APPLICATION NO.	FILING DATE	FIRST NAMED INVENTOR	ATTORNEY DOCKET NO.	CONFIRMATION NO.
10/620,410	07/15/2003	Andrew Sahr	17239	9612
26637	7590 04/06/2004		EXAM	INER
INTELLECTUAL PROPERTY LAW DEPARTMENT CASE LLC 700 STATE STREET			KOVACS, ARPAD F	
RACINE, W			ART UNIT	PAPER NUMBER
			3671	
			DATE MAILED: 04/06/2004

Application No.	Applicant(s)				
	10/620,410	SAHR ET AL.				
Office Action Summary	Examiner	Art Unit				
	Árpád Fábián Kovács	3671				
The MAILING DATE of this communication appears on the cover sheet with the correspondence address Period for Reply						
A SHORTENED STATUTORY PERIOD FOR REPLY IS SET TO EXPIRE 3 MONTH(S) FROM THE MAILING DATE OF THIS COMMUNICATION.  - Extensions of time may be available under the provisions of 37 CFR 1.136(a). In no event, however, may a reply be timely filed after SIX (6) MONTHS from the mailing date of this communication.  - If the period for reply specified above is less than thirty (30) days, a reply within the statutory minimum of thirty (30) days will be considered timely.  - If NO period for reply is specified above, the maximum statutory period will apply and will expire SIX (6) MONTHS from the mailing date of this communication.

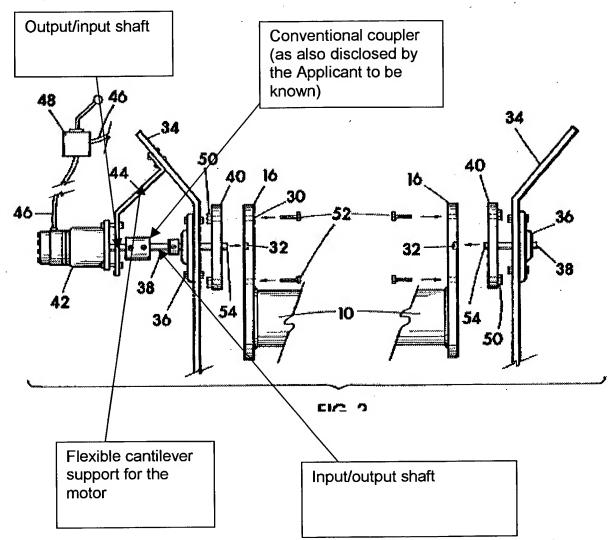
Garza discloses a harvester combine having a hydraulic motor (42) flexible support (44) output shaft and input shaft to another device to be rotated (col. 8, 1<sup>st</sup> paragraph), and shown in the marked up drawings below:

Garza discloses the claimed device except for being used for a cleaning fan assembly.

It would have been obvious to one having ordinary skill in the art at the time the invention was made to provide the motor support of Garza for any other device utilizing a motor, including a fan assembly, since it is well known to provide a support for a motor and Garza's motor support is just one of the many possibilities, which can also provide for an easy replacement of the motor when burns out or becomes defective.
